ESSEX COUNTY OFFICE OF THE MANAGER

SUBJECT: Addendum #2 BELFRY MOUNTAIN POWER INSTALL

This Addendum, issued to bid document holders of record, indicates changes to the bid documents for the *BELFRY MOUNTAIN POWER INSTALL* Bid Opening August 1, 2014.

Please replace the Underground Utility Site Plan # EX1 prepared by Infinigy with the attached one dated 7/23/14.

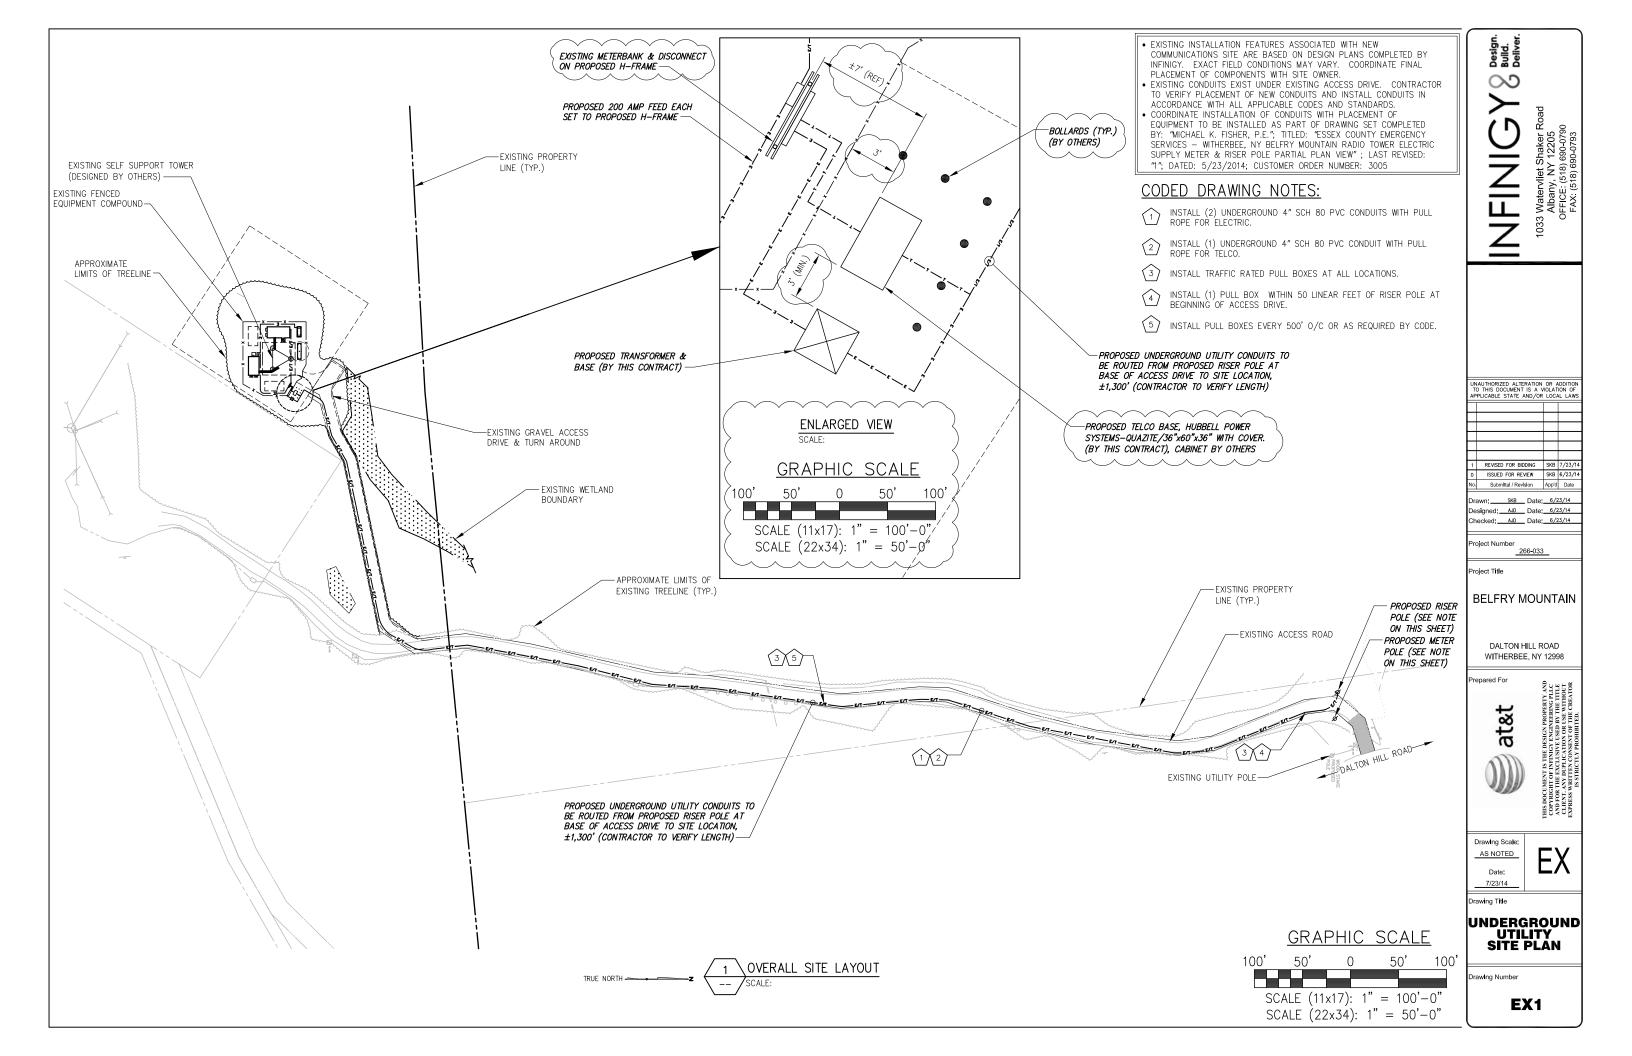
3) Drawing blow-up detail on EX-1, please clarify: length of conduit runs from proposed transformer to new 'H' frame? The overall drawing scale does not apply to the detail; On the 'H' frame, "proposed meter bank" – are the 3 loads from the new disconnect switches to be metered? Is that part of this contract scope? If so, please provide a specification/detail for the metering equipment; please provide specification/detail for any telco equipment to be installed on the 'H' frame? {Sheet EX-1 of the bid package has been revised to show dimensions and provide a scale bar and is attached; revisions are depicted within clouded areas. The SELECTED CONTRACTOR shall provide a connection internally to the meter socket and install a blank plate where the meter is to be placed. The H-Frame is a disconnect point for each tenant at the Site.}

4) Drawing EX-1 detail seems to indicate bollards are required, if so please provide specification/details for bollard construction and installation {Bollards will be installed by others after the SELECTED CONTRACTOR installs/tests the utilities and telco under this contract.}

7) Is a ground grid required at the transformer or 'H' frame? None is shown or specified: If so, please provide detail showing desired wire size and type, ground rods and method of connection (i.e. crimped, bolted, thermoweld, etc) {At the transformer, use $2 \times 10' \times \frac{3}{4}$ " copper weld steel ground rods with a #4/0, 19 strand bare copper loop 12" below grade. Bring (2) #2 bare copper pigtails into transformer terminal compartment. All below-grade connections to be CADWELD[®] or equivalent.}
